Addendum 128 – UN Regulation No. 129

Revision 1 – Amendment 6

Supplement 5 to the 01 series of amendments – Date of entry into force: 28 May 2019

Uniform provisions concerning the approval of Enhanced Child Restraint Systems used on board of motor vehicles (ECRS)

Figure A
Warning label

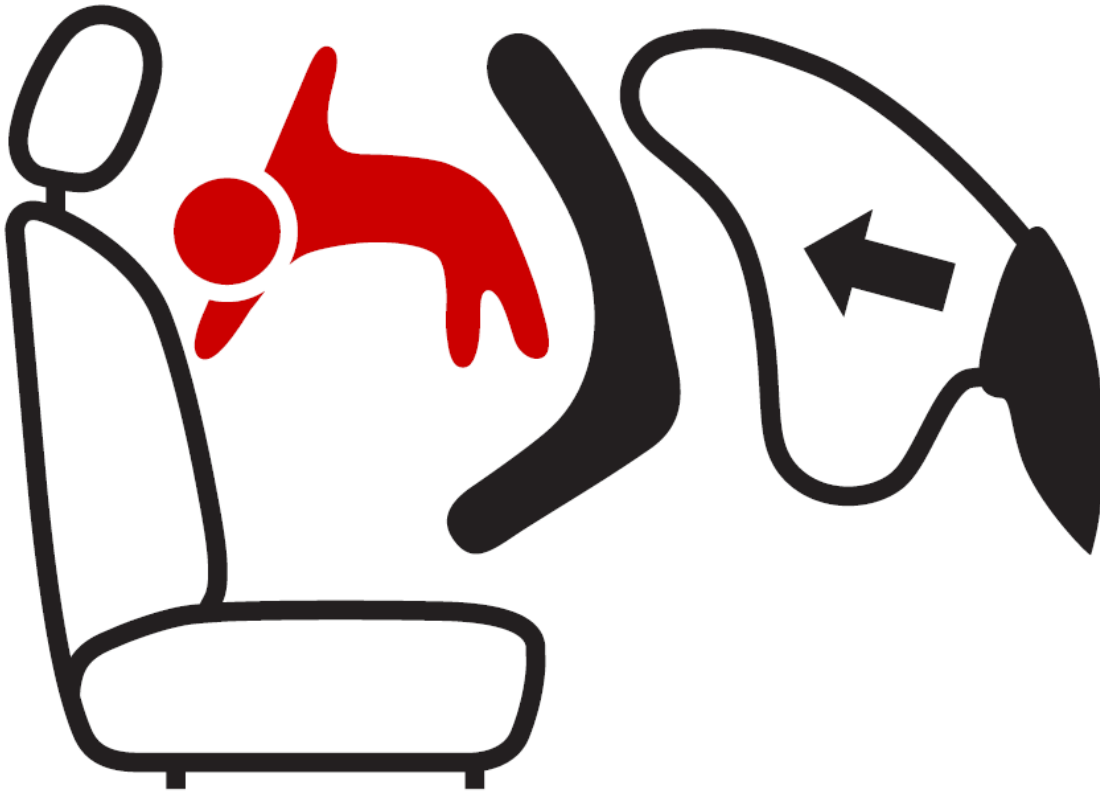
Paragraph 4.4., amend to read:

"4.4. On the visible inner surface (including the inside surface of a side wing beside the child's head) in the approximate area where the child's head rests within the child restraint system, rearward facing restraints shall have the shown label permanently attached.

The overall dimensions of the label shall be at least 120 x 60 mm or the equivalent area.

The label may be adapted in such a way that the layout differs from the example shown here; however, the content shall meet the precise prescriptions. Furthermore, no other type of information shall be included on the label unless it is placed outside a clearly marked rectangle with at least the overall dimensions as required above. In derogation to the aforementioned, a part number, bar code or similar identification mark not exceeding 8 mm x 35 mm or the equivalent area may be placed on the label.

It shall also be ensured that no deviations in the shape and orientation of the provided pictograms are permitted, notably that any customised appearance of the prescribed pictogram images shall be prohibited, with the exception of the hand with pointing index finger and the open face booklet with letter 'i' on its right page provided that they are clearly recognisable as such.

Small irregularities concerning line thickness, label imprinting and other relevant production tolerances shall be accepted.
